SUBJECT: Forwards Rev 1 to EWR 5327, "Design Verification Ginna  
 StatioContainment Foundation Mat Analysis," in response to  
 910625 request for addl info re containment integrity.

Subject: Ginna Containment Integrity  
Request for Additional Information  
R.E. Ginna Nuclear Power Plant  
Docket No. 50-244 (TAC No. 80494)

FIGURE 2

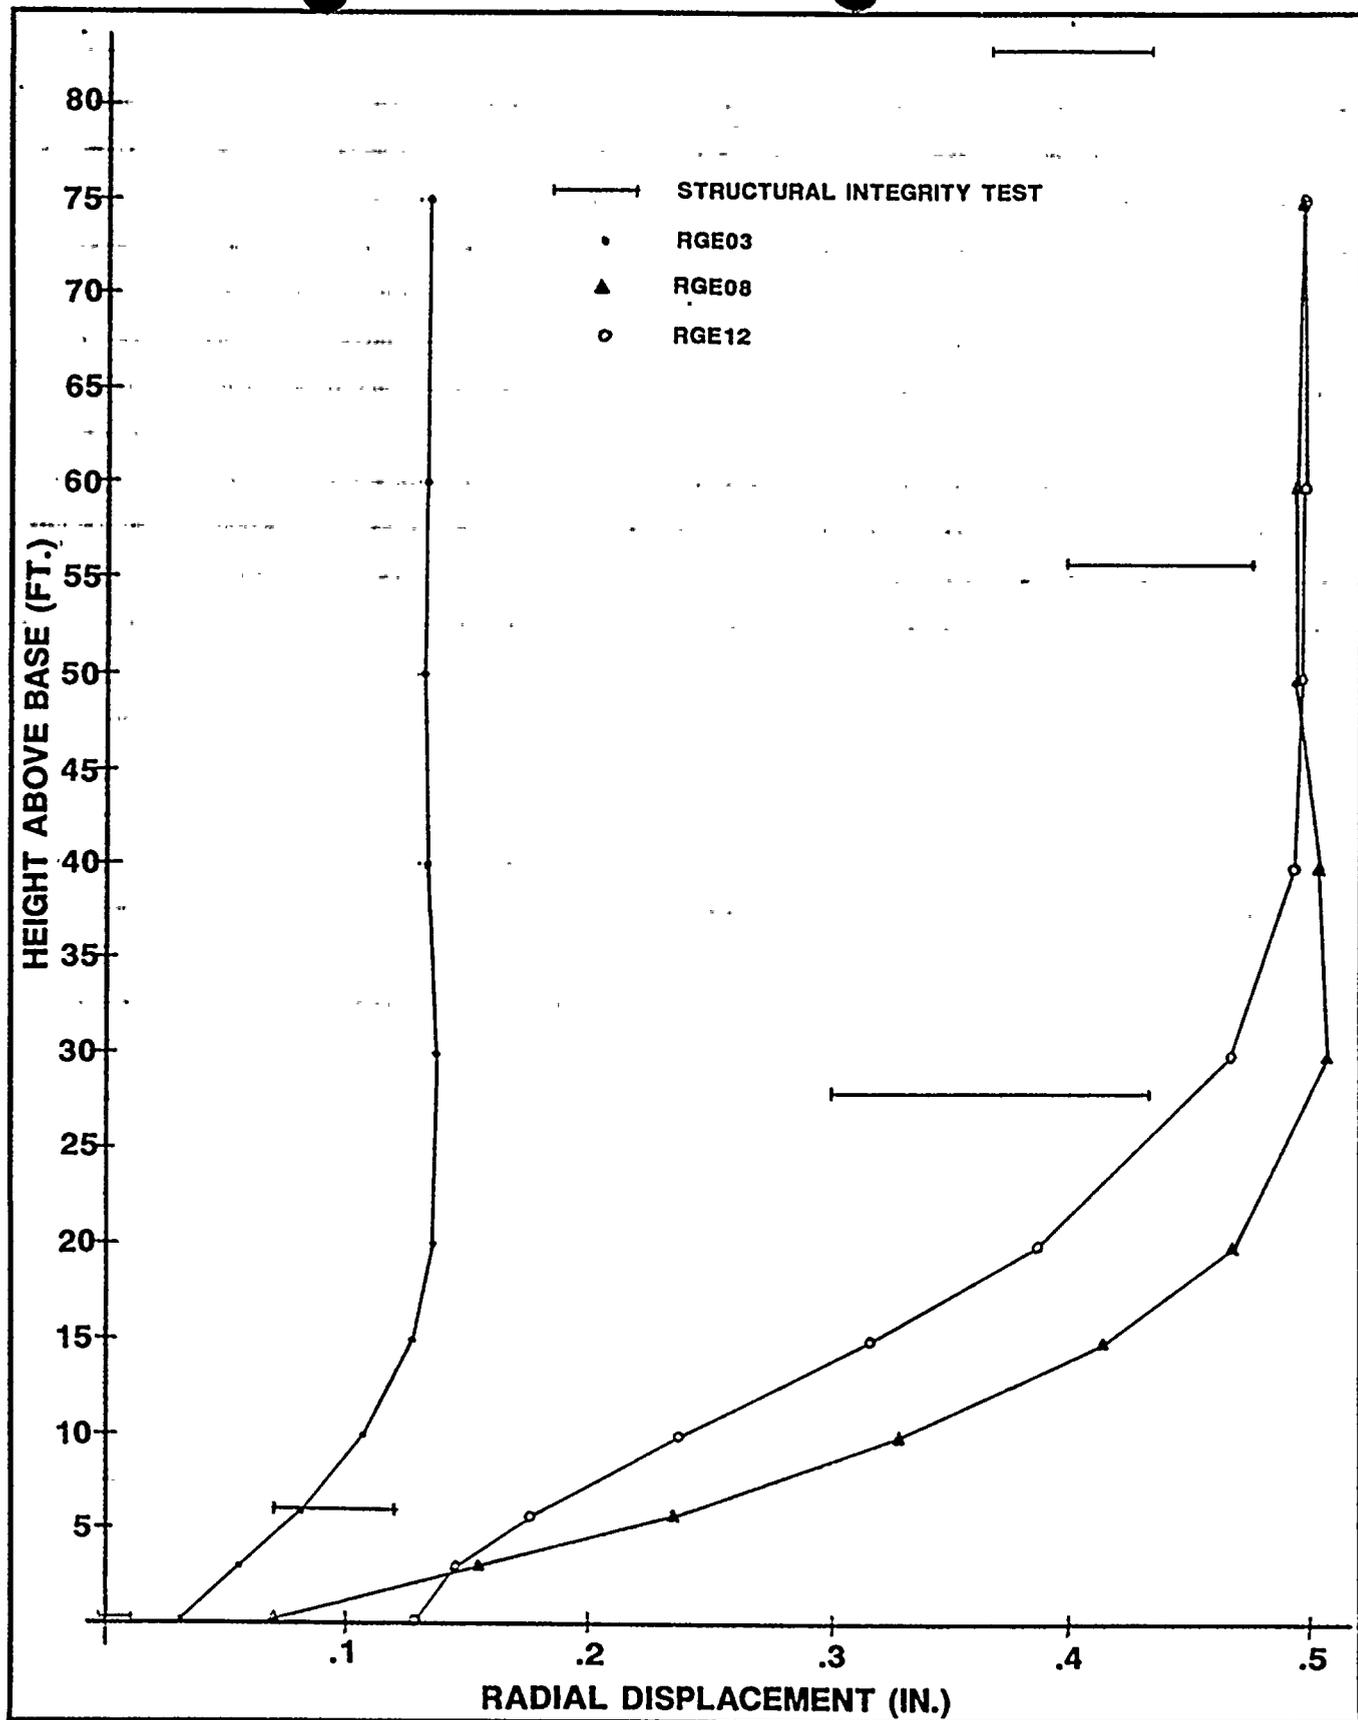
In the above comparisons where the capacity falls short of the demand induced by the appropriate load combination, provide the necessary justification for assuring containment integrity and propose what physical evidence can be obtained about the true base condition during an integrated leak rate test.

Figures 2 is a plot of radial displacements of the containment for RGE08 (pinned), RGE12 (fixed), and the results of the original Structural Integrity Test (SIT). Also shown are the displacements

for RGE03. RGE03 is the lower bound for displacements because it was run with the hoop stiffness assumed to be based on an uncracked concrete section. RGE08 and RGE12 are predictably higher than this case since these analyses were done with the hoop stiffness based on the reinforcing steel alone, which is orders of magnitude less than an uncracked section. As expected, the SIT results are between these values because the actual stiffness at the test condition, is a combination of cracked and uncracked sections.

The graph, Figure 2, displays the expected behavior of three models in relation to the SIT results. RGE03 (pinned, sliding base, uncracked concrete) matches fairly closely the SIT results near the base where you would not expect much cracking due to the presence of the radial tension bars. At higher elevations, RGE03 understates the displacements because there is cracking. The results of RGE09 (pinned, sliding base, cracked concrete) and RGE12 (fixed sliding base, cracked concrete), overstate the displacements

at all locations, as expected, but are closer to the SIT values at higher elevations.
